PCN Number: 0902

PCN Level: Minor

Subject: Minor Fix to Axcelerator® and RTAX-S Programming (*.afm) File Generation to Address Programming Failure for Specific Conditions Only

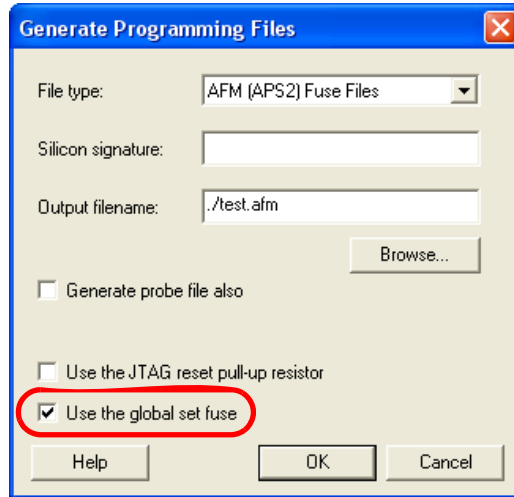
Actel has successfully completed the investigation and determined the root cause of programming yield loss. Analysis performed on the programming failures revealed that the special antifuse referred to as "GBSETFUS" fails programming. This antifuse is included in the AFM file for programming if and only if the **Use the global set fuse** option is selected in the Generate Programming File window in the Designer suite, as shown below. This specific antifuse (GBSETFUS) can be invoked during generation of programming file (*.afm) to set the internal registers (R-cells) to a value of "1" after power up. An error in the Designer software resulted in an incorrect condition being set for this antifuse in the AFM file when it was addressed by the Silicon Sculptor programming software, thereby resulting in this programming yield loss.

1. If the **Use the global set fuse** is not selected (unchecked in Designer), there is no issue and no action is required.
2. If you are currently using the **Use the global set fuse** option and have not experienced any programming yield loss, the successfully programmed devices are reliable. Actel recommends regenerating the programming file (*.afm) if additional devices need to be programmed. Customers should use the Libero IDE service pack referenced above.
3. If **Use the global set fuse** option is selected and you have experienced any programming failures, the devices that failed to program should be returned to Actel. Please contact Actel's technical support team to initiate an RMA. To prevent additional programming yield loss, the programming file (*.afm) must be regenerated using the Designer software capture referenced below.

A Libero® Integrated Design Environment (IDE) software fix (release number 8.5SP1) has been implemented to ensure correct addressing of this particular antifuse, thereby eliminating these programming failures. This software fix requires regeneration of the programming file (*.afm). The modified software can be found from: <http://www.actel.com/download/software/libero/libero85rlsp1.aspx>

4. If you plan on using the **Use the global set fuse** option (for those customers in design phase), you must ensure that the programming file (*.afm) is generated with the Libero IDE Service Pack 8.5SP1.
